# WisDOT Bridge Manual

## July 2024 Updates

James Luebke, P.E.  
Policy and Standards Engineer  
August 21<sup>st</sup>, 2024

Std. 30.15

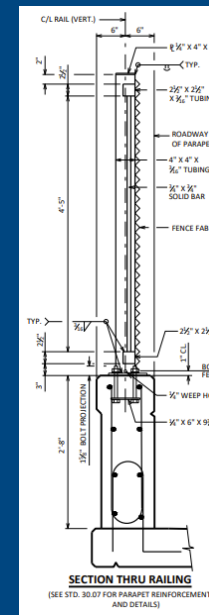
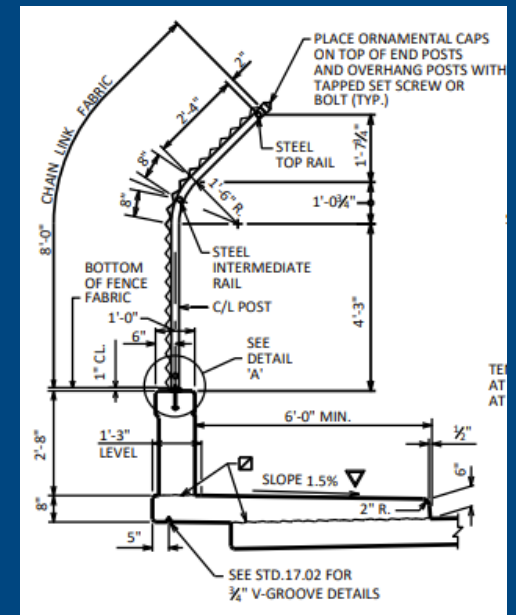
- Chapter 30 – Protective Screening
  - Added guidance for protective screening height
    - 8-ft minimum above surface (preferred)
    - 6-ft minimum may be considered (with reduced level of protection)
  - Most snoopers trucks: 10'-0" to 11'-0" vertical allowance
  - For highly vulnerable areas, consider 1" by 1" mesh
  - The designer should coordinate fence height, fence shape (vertical or bent), and mesh size with the Region and all other applicable agencies

- Chapter 30 – Protective Screening
  - Tubular Steel Railing Screening
  - Chain Link Fencing

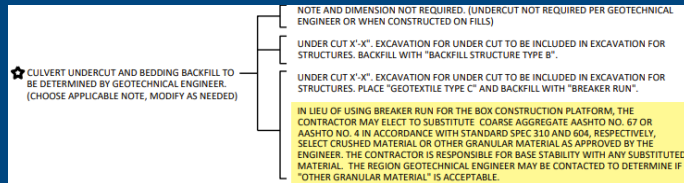
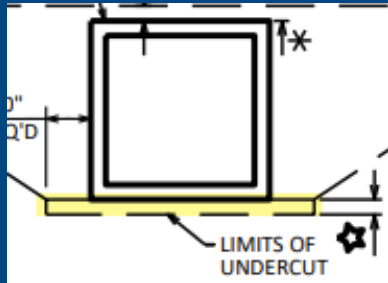
- Standards – Material Changes:
  - #1 Concrete Coarse Aggregate → Coarse Agg. AASHTO No. 67
    - Gradations: 2025-Std Spec. 310-Open Graded
    - Usage: Box culvert base substitution/Modular Block Wall/Gravity Wall (Drainage Blanket)
  - #2 Concrete Coarse Aggregate → Coarse Agg. AASHTO No. 4
    - Gradations: 2025-Std Spec. 604 – Slope Paving
    - Usage: Box culvert base substitution

Std. 9.02 (No. 67, No. 4)

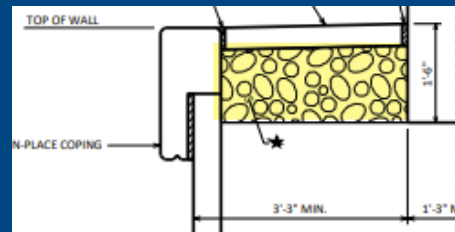
- Standards 9.02, 14.04, 14.11, 14.14, & 36.12

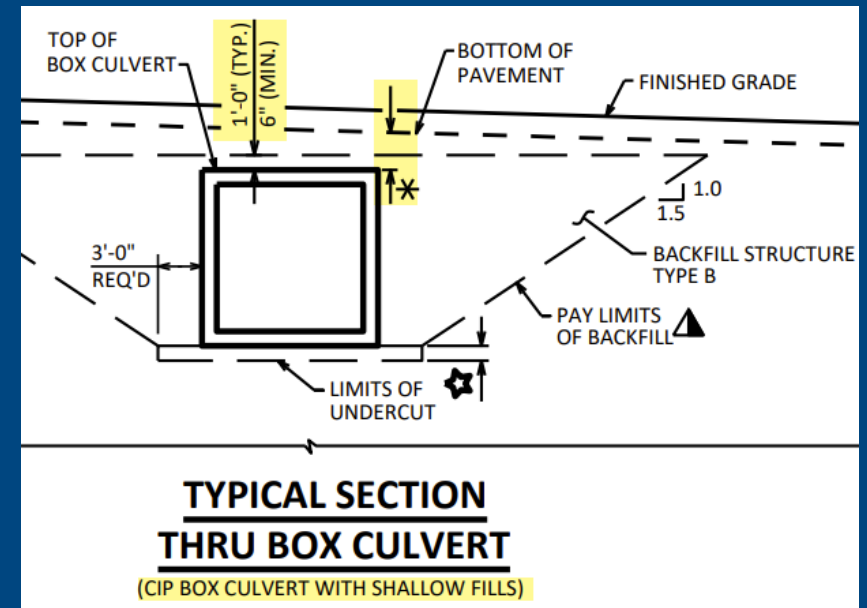
- Standard 9.02
  - Removed 1'-0" (Ideal) cover
  - Added 6" min. cover between T/box and B/Pavement (flexible or rigid)

\* 6" MINIMUM OF "BACKFILL STRUCTURE TYPE B" REQUIRED BETWEEN BOTTOM OF ROADWAY SURFACE AND TOP OF CULVERT.

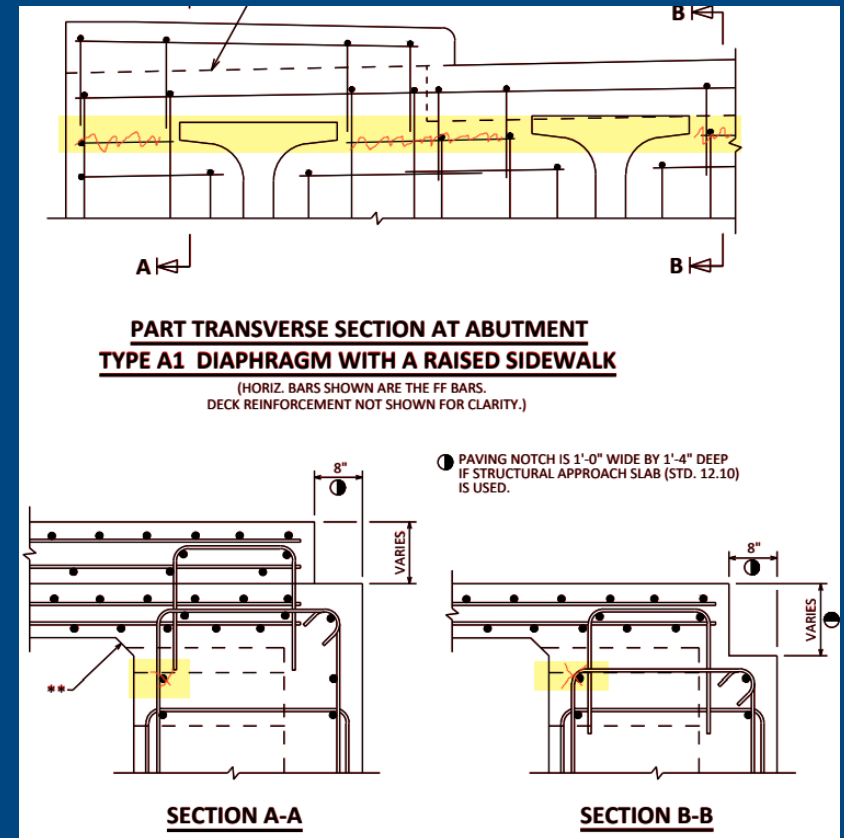
- Standard 17.01
  - Removed horizontal diaphragm bars to match Std. 19.34 and Std. 19.35 details

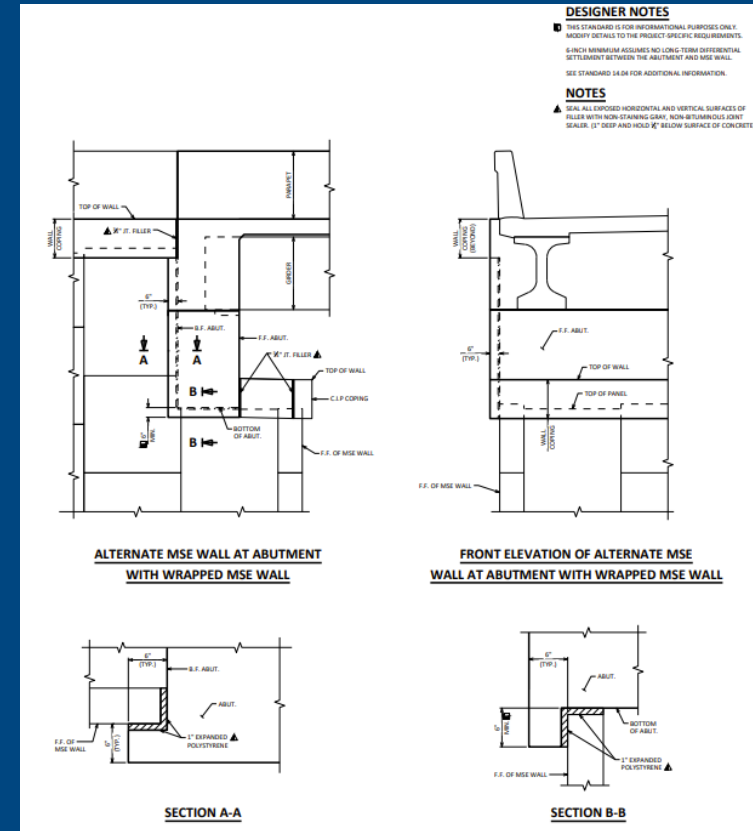
- Standard 14.06 (New)
  - MSE Wall at Abutment Details (wrapped)
  - General layout provided; final details still required.
  - MSE wall aligned with CL of abutment (not wrapped) is still preferred.

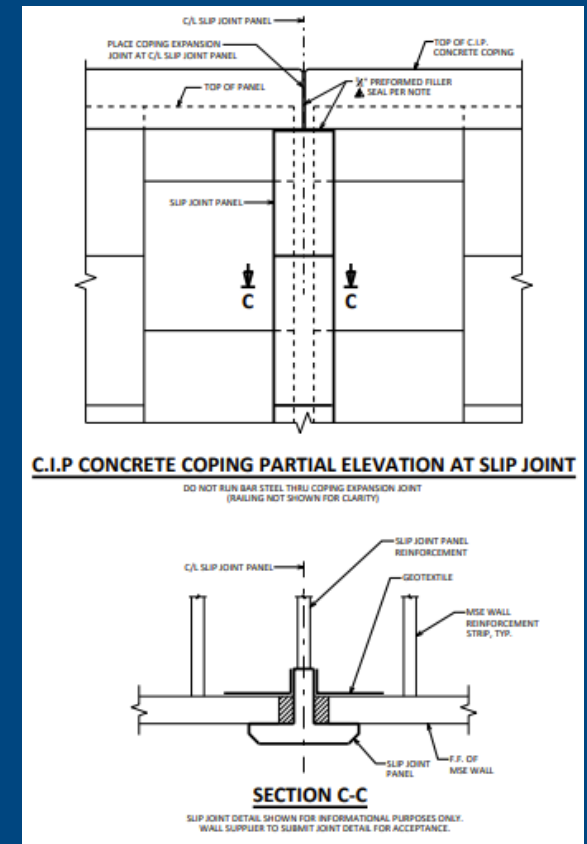
- Standard 14.06 (New)
  - MSE Wall Slip Joint
  - Details to ensure proper CIP concrete details
  - Provide slip joint locations on the plans
  - Do not run bar steel thru coping expansion joints

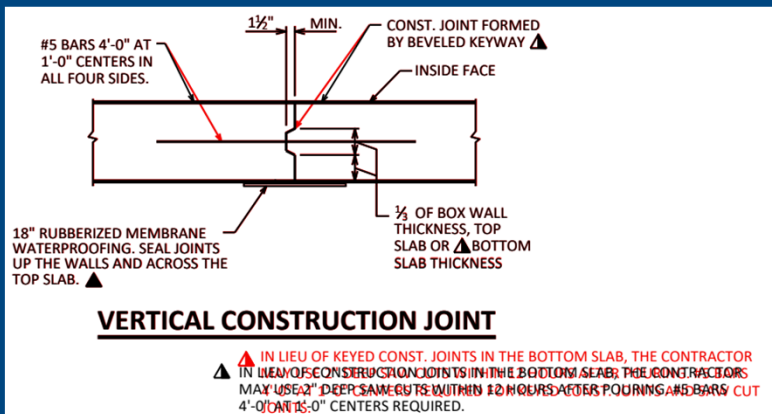
- Standard 36.03 – Box Culvert Details
  - Updated arrowhead locations
  - Updated note clarifying #5 bars required for keyed and saw cut joints in bottom slabs.

**IN LIEU OF KEYED CONST. JOINTS IN THE BOTTOM SLAB, THE CONTRACTOR MAY USE 2" DEEP SAW CUTS WITHIN 12 HOURS AFTER POURING. #5 BARS 4'-0" AT 1'-0" CENTERS REQUIRED FOR KEYED CONST. JOINTS AND SAW CUT JOINTS.**

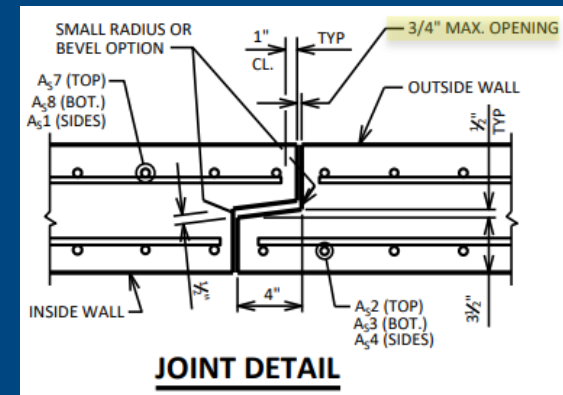
- Standard 36.05 – Box Culvert Details
  - Provided 3/4-inch maximum joint opening between box sections
  - Changed joint seal requirement from AASHTO M198 Type B on 3-sides to ASTM C990 on all 4-sides.
    - ASTM M198 (withdrawn)
    - Both ASTM's are similar (preformed butyl rubber)

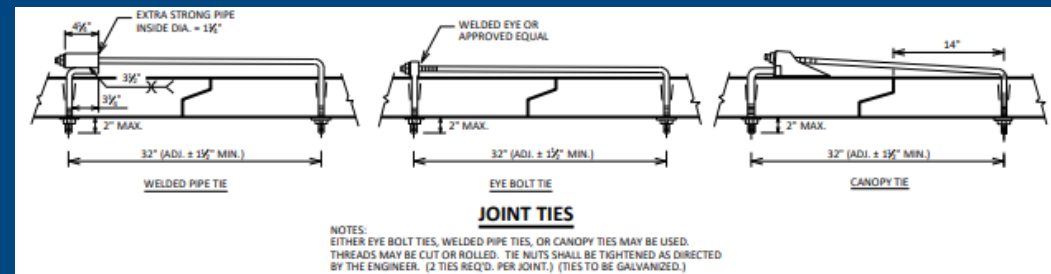
- Standard 36.05 – Box Culvert Details
  - Added Designer Note regarding joint ties (only required between the last two-barrel sections for skewed culverts).
  - The designer shall determine if additional joint ties are warranted.
  - Provide plan note identifying required joint tie locations
